FCI (BD) Ltd -Extended New Warehouse Building

Plot No: 83-84, DEPZ (Old Zone), Ashulia, Savar, Dhaka-1349.

24 January 2024

Observation-1: Possibility of Vertical Extension. Building-1 (Factory Building)

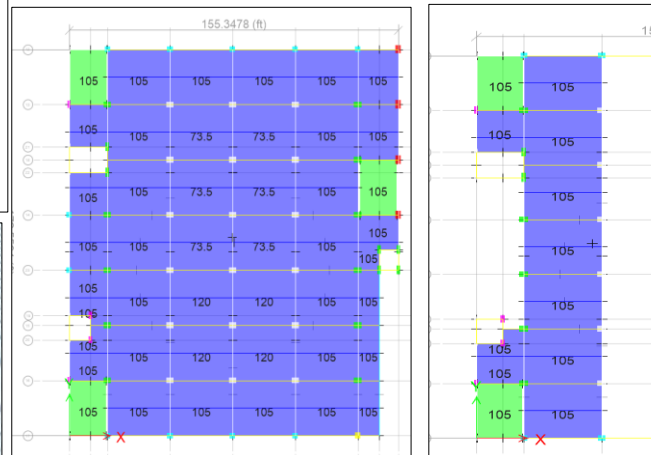
Description: The building permission layout is for eight storied structures approved by BEPZA. The construction of the building started in February 2019 and completed up-to 1st floor level in January 2023. Extended columns were observed on the roof. So, there is a possibility of future vertical extension. The building engineer is required to conduct Detail Engineering Assessment (DEA) for the eight storied structure prior to commencement of further extension work and submit to RSC for further review.

In the provided load plan, 6kPa has been considered at 1st floor (existing roof) and partial area of the mezzanine. But in FEA model, the floor loading has been assigned less than 6kPa.

In design report, design concrete strength has been considered 5000psi for the column, beam and slab as well as assigned in FEA model. During inspection, Nineteen sets of concrete cylinder test reports from BUET where ten sets for Column, three sets for slab, three sets for pile cap & three sets for pile. The average cylinder strength of a ground floor lift column was found less then the design strength. Building engineers is required to verify the in-situ concrete strength for the column.

Serial No	Observation	Action Plan	Timeline
1	Possibility of Vertical Extension. Building-1 (Factory Building)	Prior to the vertical extension, the building engineer is required to conduct a Detailed Engineering Assessment (DEA) of the structure according to BNBC. Submit DEA to RSC for review.	within 6 months
2	Possibility of Vertical Extension. Building-1 (Factory Building)	Carry out remedial work if required.	within 6 months
3	Implement load management programs properly. Building-1 (Factory Building)	Post the load plan and maintain loading accordingly.	within 6 weeks
4	Hairline cracks in brick wall. Building-1 (Factory Building)	The building engineer is required to investigate the reason of crack, extend of crack and suggest proper remedial action.	within 6 weeks
5	Non-structural elements not anchored or braced. Building-1 (Factory Building)	Building engineer is required to adequately anchor and brace all non-structural elements to resist earthquake forces to comply with the BNBC.	within 6 months

Observation-2: Implement load management programs properly. Building-1 (Factory Building)

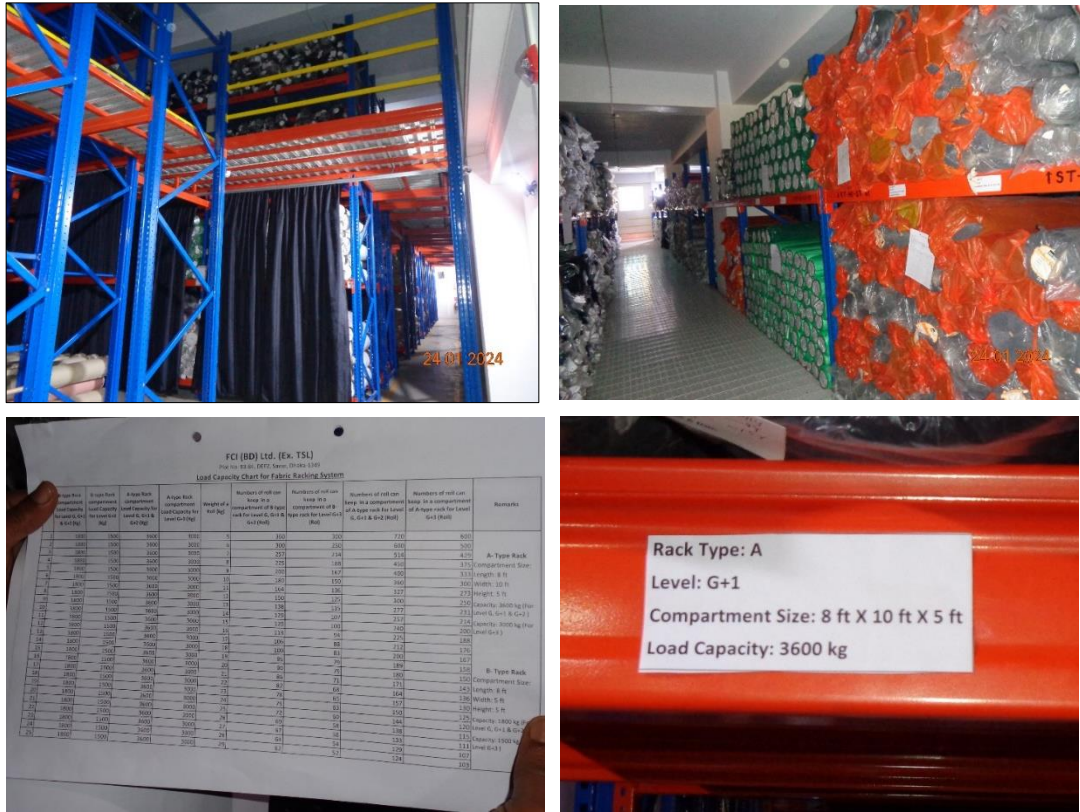
Description: During the inspection, two storage racks were found on ground floor. Load plan or loading capacity has been provided by the manufacturer of racks. But the load management program was not found as per the capacity. The building engineer is required to post load plan for racks all around the floors and maintain the loading in rack as per the capacity.
